EG/18/12/NMA

Shelly House Planning Amendments & Differences From Original R.JCA Chartered Architects Drawing No. 07 / 49 / 03, Rev B, dated July '08

Elm Tree Stores & Shelly House design changes to elevation views comprising:

Client	MR G BRAMLEY / MR D TOBIN				
Job title	SHELLEY HOUSE / ELM TREE STORES NYTON ROAD, EASTERGATE WEST SUSSEX, PO20 3UP				
Drawing title	ELEVATIONS, AS PROPOSED				
Drawn	Date	Checked	Date	Scale at A1	
TR	05-09-11		05-09-11	1:100	
Job N°	Drawing N°		Rev.		
11-032	30-02			A	
Status

E01 - Front Elevation - Shelley House (Units 7 & 8)

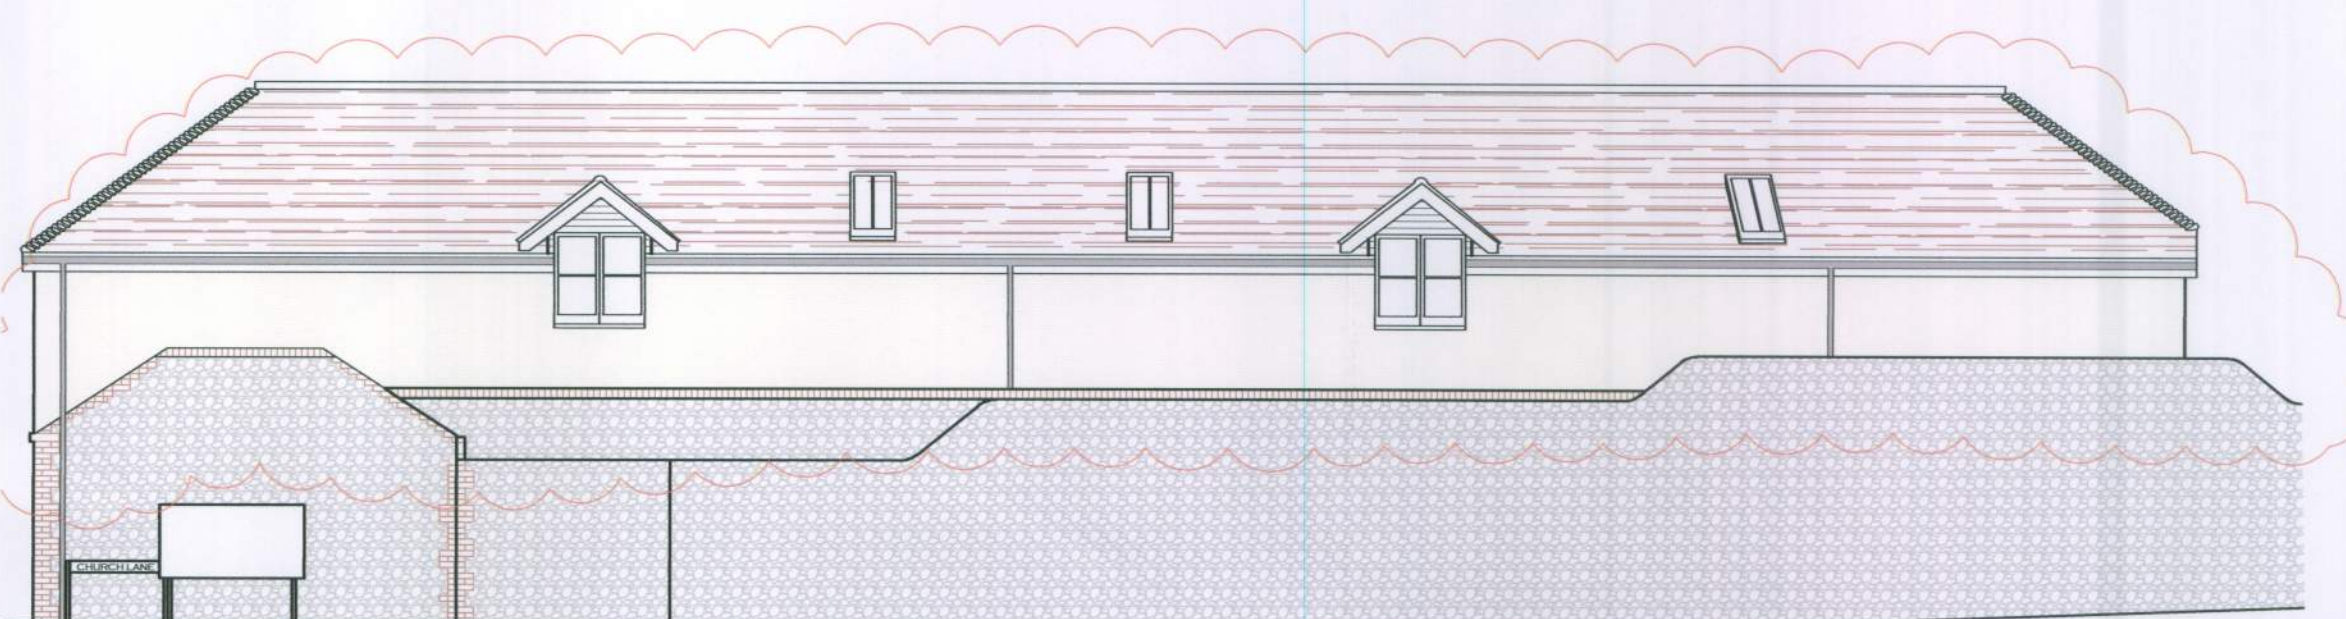
E01: Brick buttresses omitted due to new less intrusive structural tie option.

E02 - Shelley House (Units 6, 7 & 8) Elevation

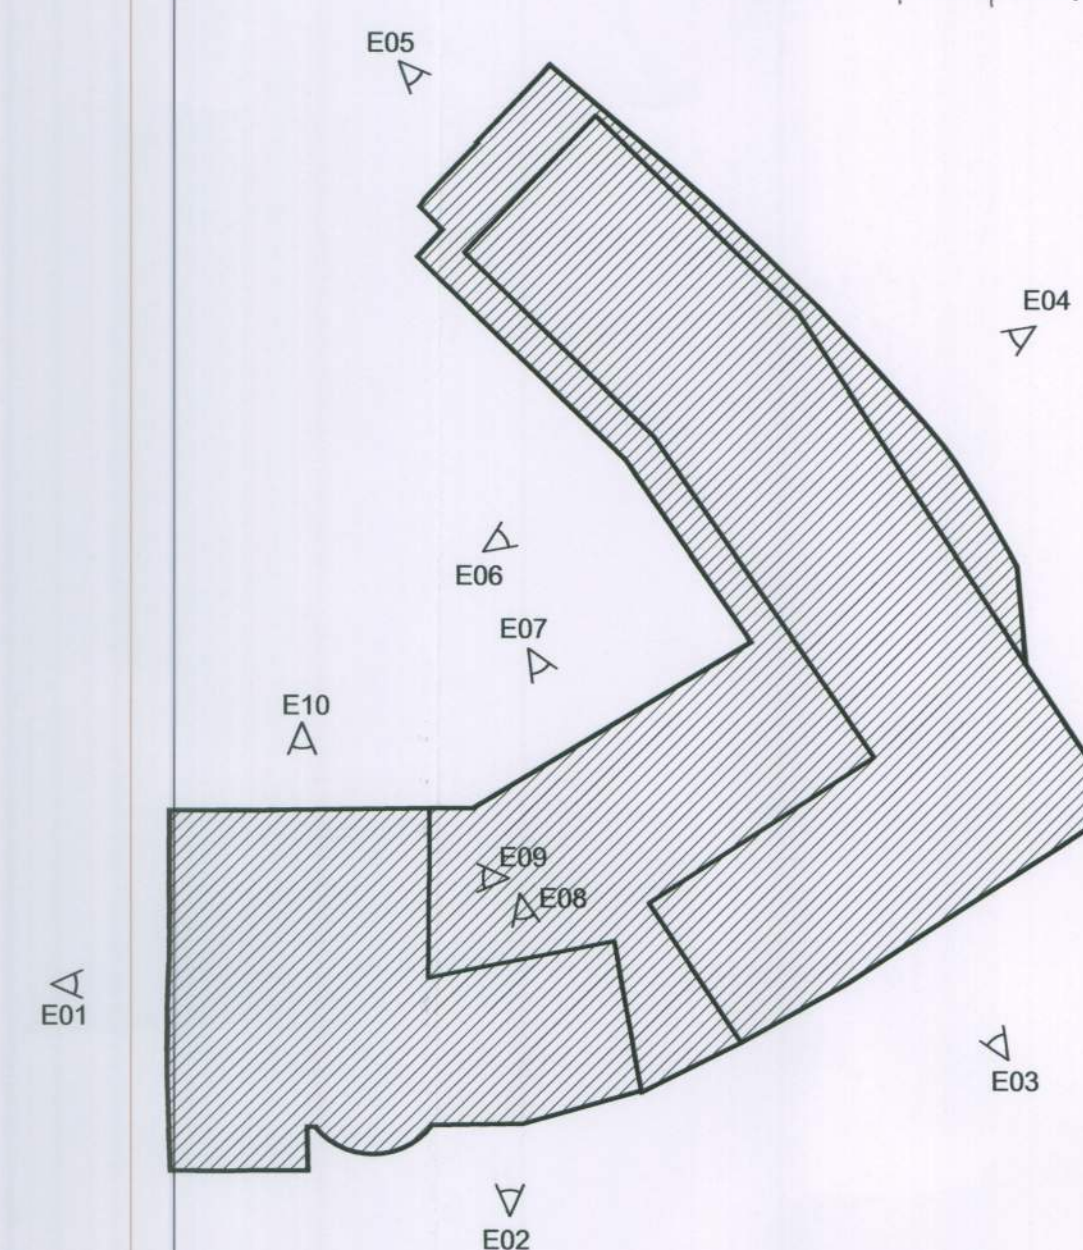
E02 / E03: Additional conservation rooflight added to Unit 6 kitchen. Wall construction to first floor extension changed from flint finish to painted lime render finish, pitched roof changed from slate roof to handmade plain clay tile roof, layout of dormer windows and additional conservation rooflights change due to layout amendments to units 4 & 5.

E04 - Church Lane Street Elevation - Elm Tree Stores (Units 1, 2, 3 & 4)

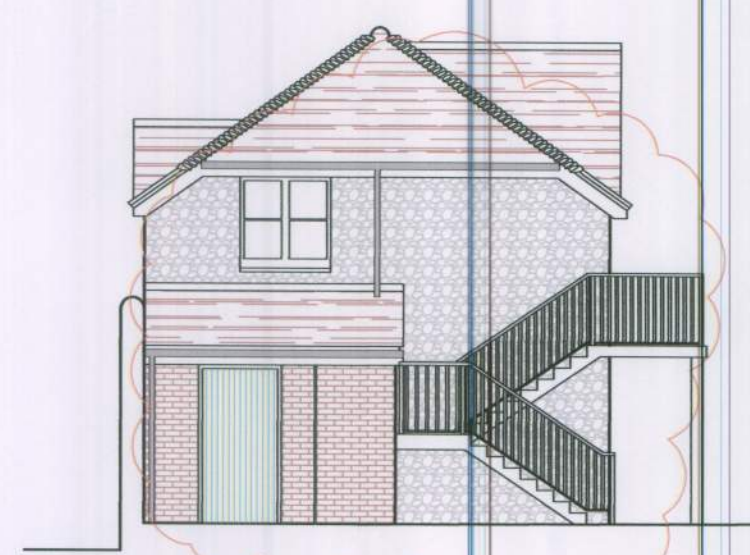
E04: Wall construction to first floor extension changed from flint finish to painted lime render finish, pitched roof changed from slate roof to handmade plain clay tile roof, 3 No. conservation rooflights omitted.

E06 - Elm Tree Stores Rear (Units 1, 2, 3 & 4) Courtyard Elevation / Section

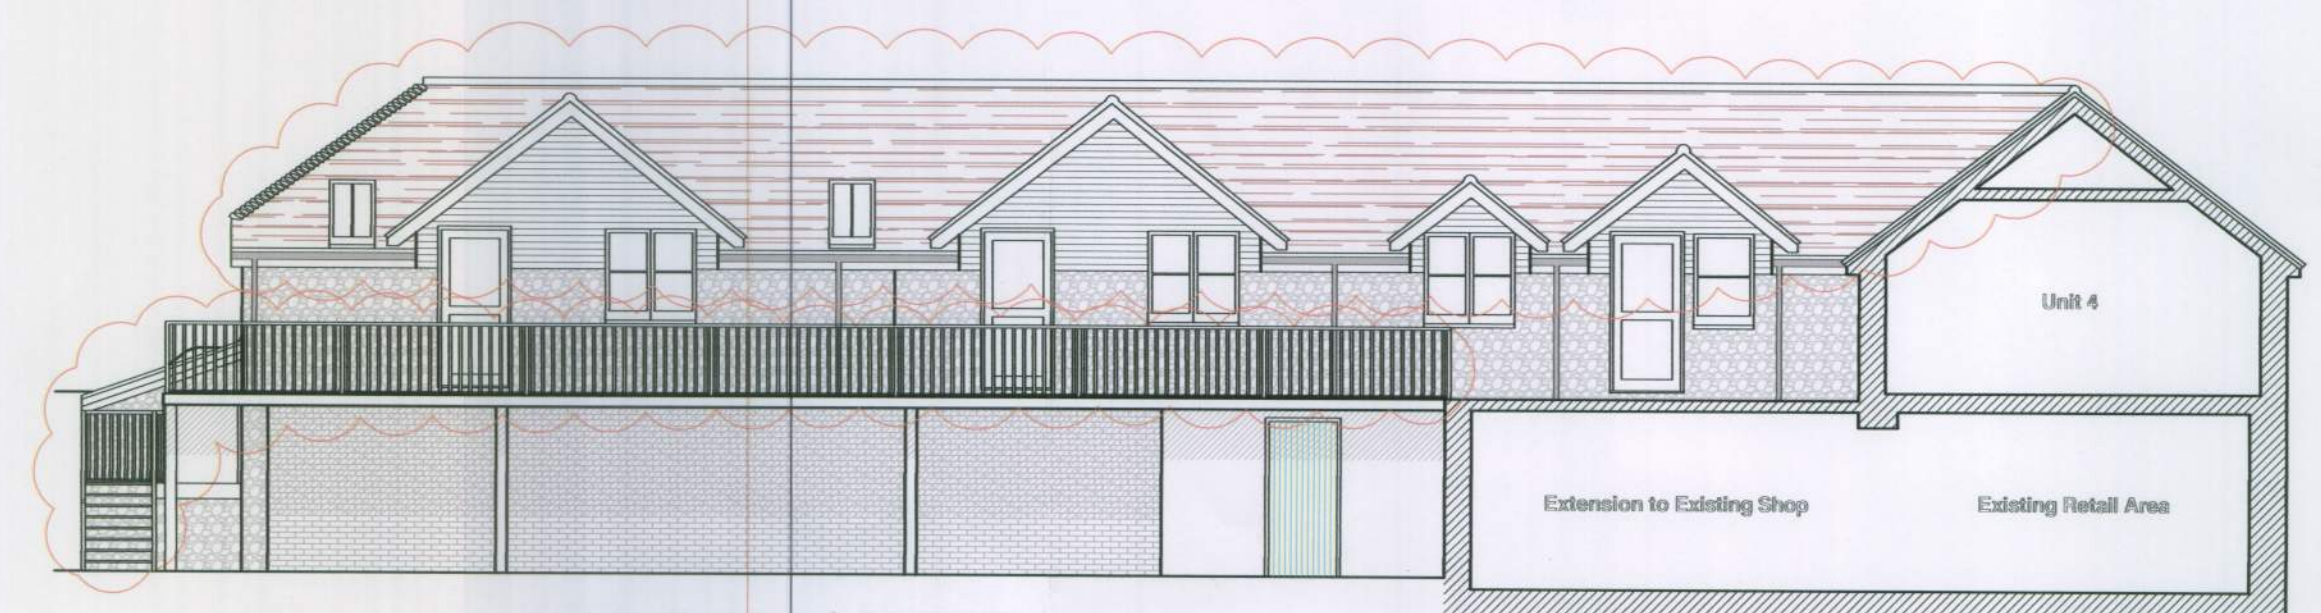
E06: Pitched roof changed from slate roof to handmade plain clay tile roof, 2 No. new conservation rooflights added to bathrooms in Units 1 & 2 and timber staircase and balustrade changed from timber to metal.

E07 - Elm Tree Stores / Shelley House Rear (Units 3, 4, 5 & 6) Courtyard Elevation / Section

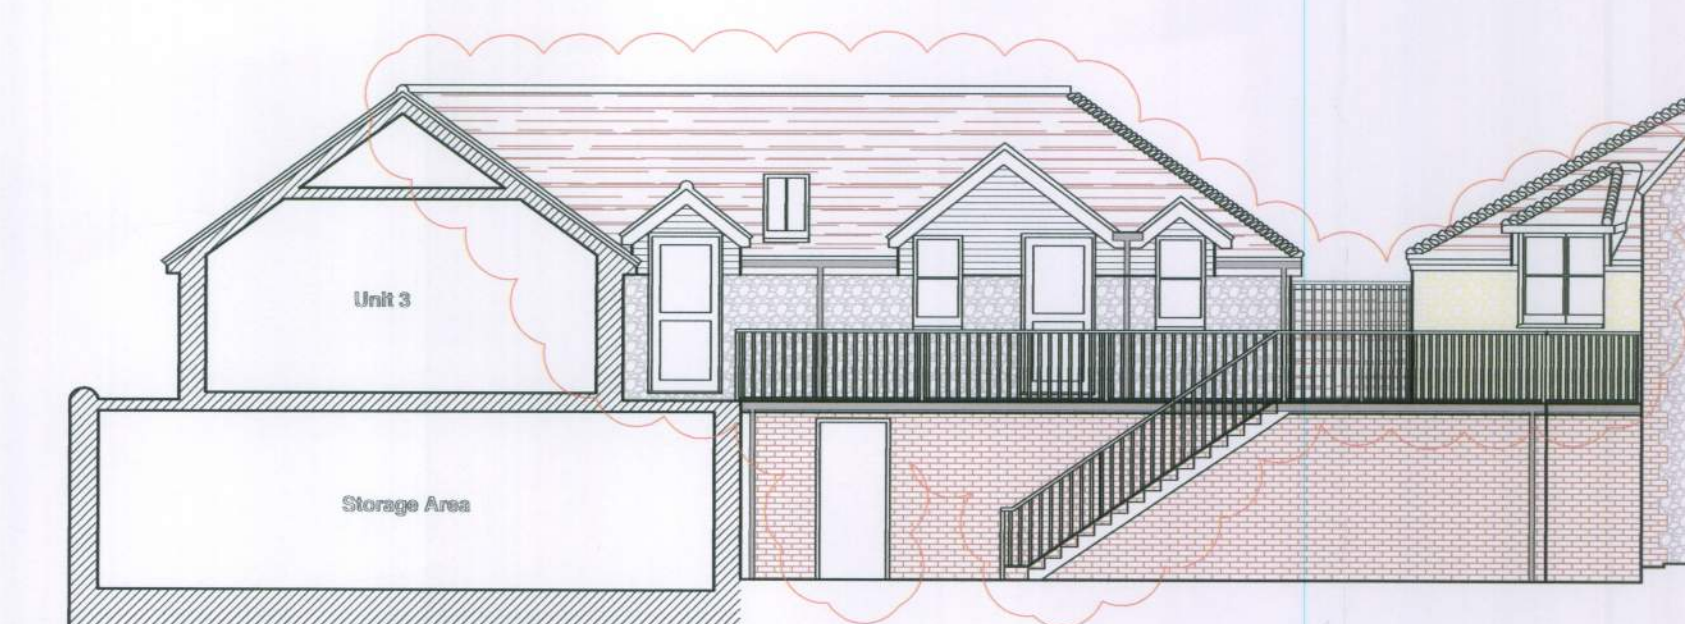
E07: Pitched roof changed from slate roof to handmade plain clay tile roof, 2 No. new conservation rooflights added to Unit 4 bathroom, new window with dormer above to suit new layout of Unit 5, timber balustrade changed from timber to metal, new 2.1 m high security barrier spanning between corner of Unit 5 to corner of Unit 6 to increase security to low level single storey section of pitched roof and new security steel fire exit door added to extension at rear of shop.

E08 - Shelley House Rear (Unit 6) Elevation / Section

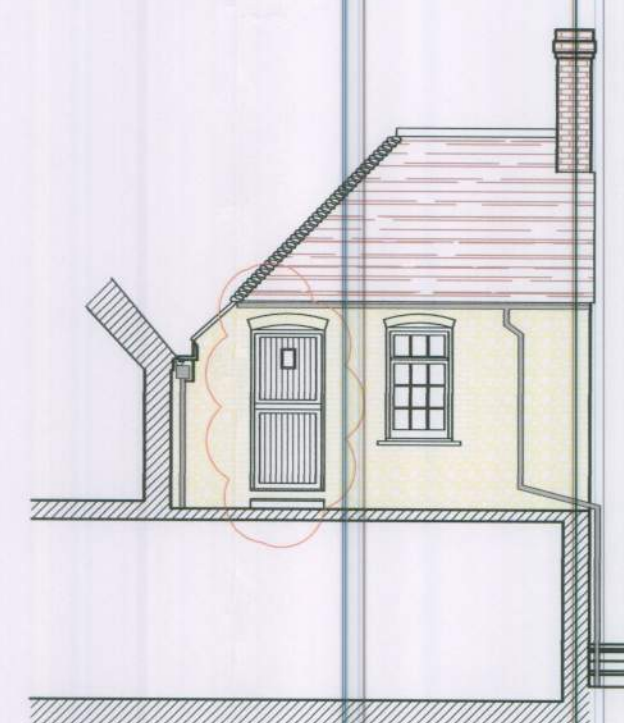
E08: Entrance to Unit 7 omitted and dormer roof adjusted to suit.
